# UNITED STATES PATENT AND TRADEMARK OFFICE

APPLICATION NO.	FILING DATE	FIRST NAMED INVENTOR	ATTORNEY DOCKET NO.	CONFIRMATION NO.
09/835,711	04/16/2001	Kia Silverbrook	360040-21	7729

**Office Action Summary**

U.S. Patent Feb. 6, 1990 Sheet 1 of 3 4,899,174

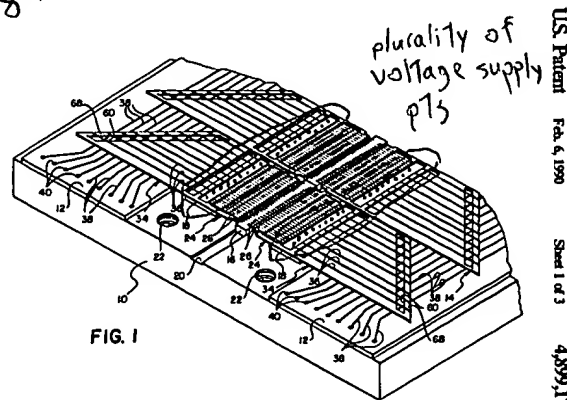
Newman discloses, with respect to claim 130,

- a power distribution arrangement (See figure, reference 38; column 4, lines 1-11)
- for an elongate printhead (See figure 1, references 16, 18; column 1, lines 1-22)
- of a kind having a plurality of longitudinally spaced voltage supply points (See figure 1, drawn-in reference)

printhead represented  
by "16" and "18"

- interconnect means connecting the voltage supply points to power (See figure 1, reference 36, 38; column 4, lines 1-11)

Newman discloses, with respect to claim 134, that the interconnect means also includes a plurality of control lines for connection to selected others of the voltage supply points on the printhead (See figure 1, references 36, 38; column 4, lines 1-11).

Newman discloses, with respect to claim 135, that the interconnect means is in the form of one or more circuit boards, with **TAB** connecting printed circuit boards to the printhead (See figure 1, reference 12; column 1, lines 15-22; column 3, lines 39-43).
